UNITED STATES PATENT AND TRADEMARK OFFICE

APPLICATION NO.	FILING DATE	FIRST NAMED INVENTOR	ATTORNEY DOCKET NO.	CONFIRMATION NO.
10/808,497	03/25/2004	Sung-ho Kim	SEC.1147	5716
20987	7590	01/24/2006	EXAMINER	
VOLENTINE FRANCOS, & WHITT PLLC ONE FREEDOM SQUARE 11951 FREEDOM DRIVE SUITE 1260 RESTON, VA 20190			NGUYEN, THINH T	
			ART UNIT	PAPER NUMBER
			2818

Office Action Summary	Application No.	Applicant(s)	
	10/808,497	KIM ET AL.	
	Examiner	Art Unit	
	Thinh T. Nguyen	2818

DETAILED OFFICE ACTION

*FIG. 4*

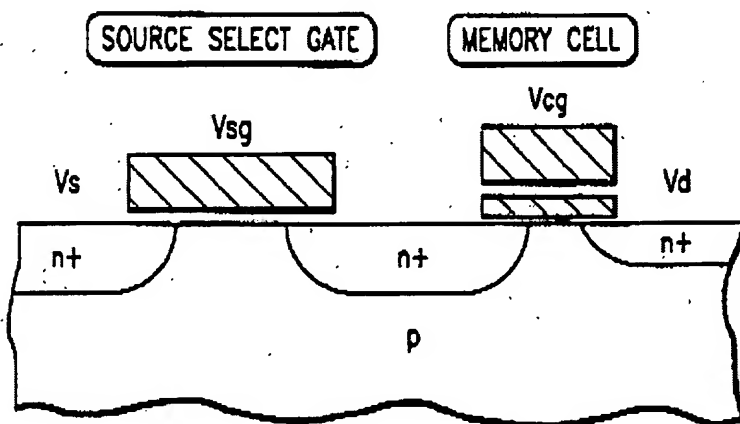
Cappelletti 913 (in the Abstract, in fig 1, fig 3, fig 4) discloses a nonvolatile semiconductor memory device comprising: a semiconductor substrate comprising an active region and an isolation region; 1-byte memory transistors arranged in a first

direction, wherein each of the 1-byte memory transistors includes a junction region and a channel region formed in the active region of the semiconductor substrate; and a byte select transistor disposed in the active region, wherein the byte select transistor includes a junction region that is directly adjacent to the junction of each of the 1-byte memory transistors. (noted that the source selected gate is the byte selected transistor since in fig 3 the drain of the source select transistor in Cappelletti 913 reference is connected to the segment of 8 drains of 8 transistors of the byte memory cells).

Cappelletti 913 (in the Abstract, in fig 4) discloses a non-volatile semiconductor memory wherein the junction region and a channel region of the byte select transistor are disposed in an undoped native semiconductor substrate.

FIG. 3

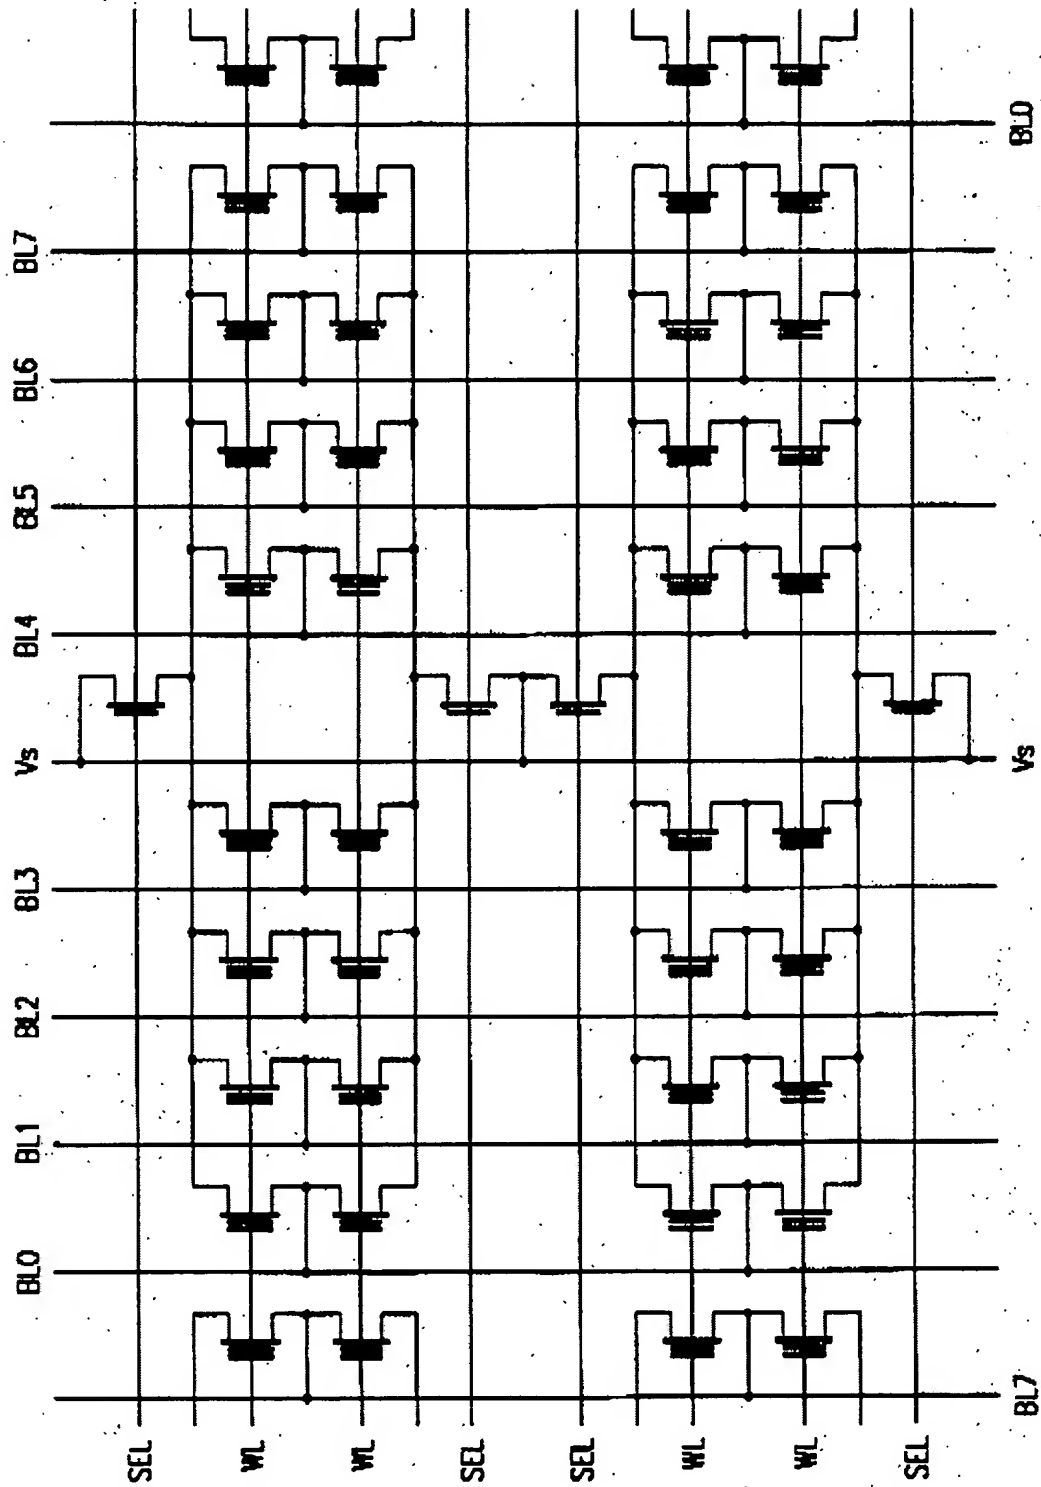
Cappelletti 913 (in the Abstract, in fig 3, fig 4) discloses a non-volatile semiconductor memory wherein the byte select transistor is disposed over or under the 1-byte memory transistors perpendicular to the arranged direction of the 1-byte memory transistors.

Cappelletti 913 (in the Abstract, in fig 3, fig 4) discloses a non-volatile semiconductor memory wherein the junction of each of the 1-byte memory transistors that is directly adjacent to the junction of the byte select transistor is a source region.

Cappelletti 913 (in the Abstract, in fig 3, fig 4) discloses a non-volatile semiconductor memory wherein each of the 1-byte memory transistors is a floating-gate-type transistor

FIG. 7

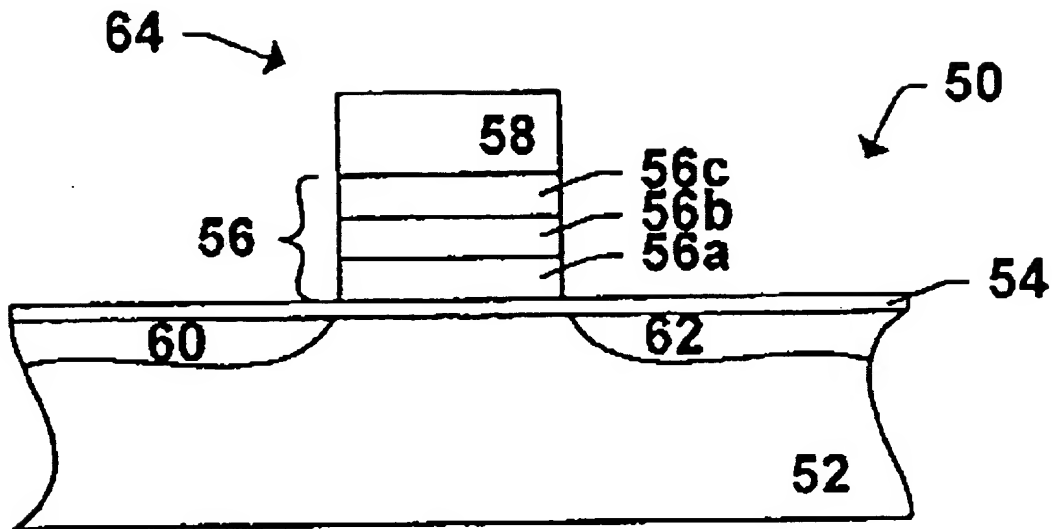
Cappelletti discloses all the invention except for the use of memory cell structure using silicon-oxide-nitride-oxide-silicon-type transistor ; Wu, however, (in the abstract, in fig 7) discloses a flash memory cell having silicon-oxide-nitride-oxide-silicon-type transistor. It would have been obvious to one of ordinary skill in the art the time the invention was made to complement the teachings by Cappelletti with the teachings by Wu and come up with the invention of claims 12

Wu discloses a non-volatile memory device, (in the abstract, in fig 7) wherein a gate electrode structure of the silicon-oxide-nitride-oxide-silicon-type transistor type includes a first oxide layer, a nitride layer, a second oxide layer, and a conductive layer, which are sequentially stacked and have substantially the same width. The rationale as why claim 13 is obvious over Cappelletti in view of Wu has been set forth in the rejection of claim 12 above.

FIG. 7B

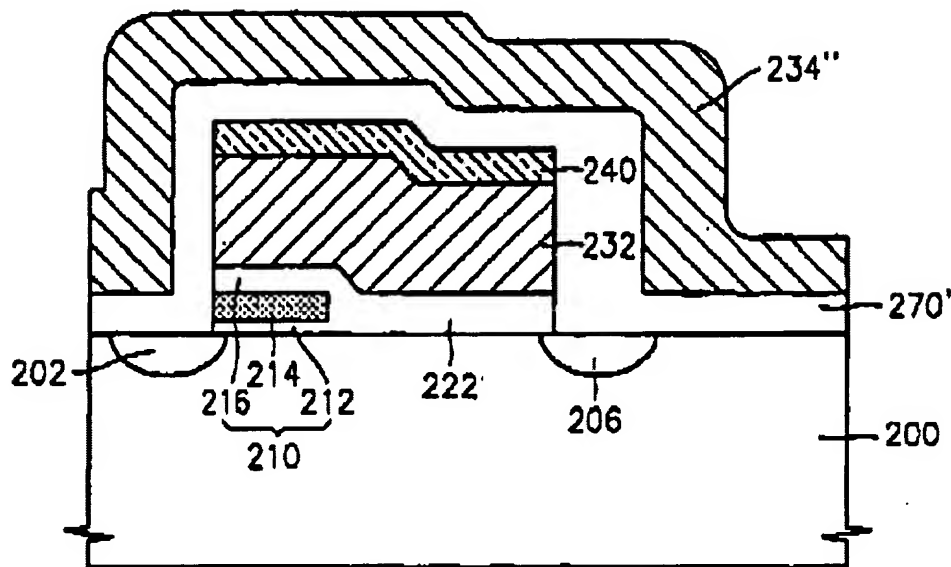
Cappelletti discloses all the invention except for the use of memory cell structure using silicon-oxide-nitride-oxide-silicon-type transistor ; Kang however, (in the abstract, in fig 7A) discloses a non-volatile memory cell having silicon-oxide-nitride-oxide-silicon-type transistor.

Kang however, (in the abstract, in fig 7A) discloses a non-volatile memory cell having silicon-oxide-nitride-oxide-silicon-type transistor.
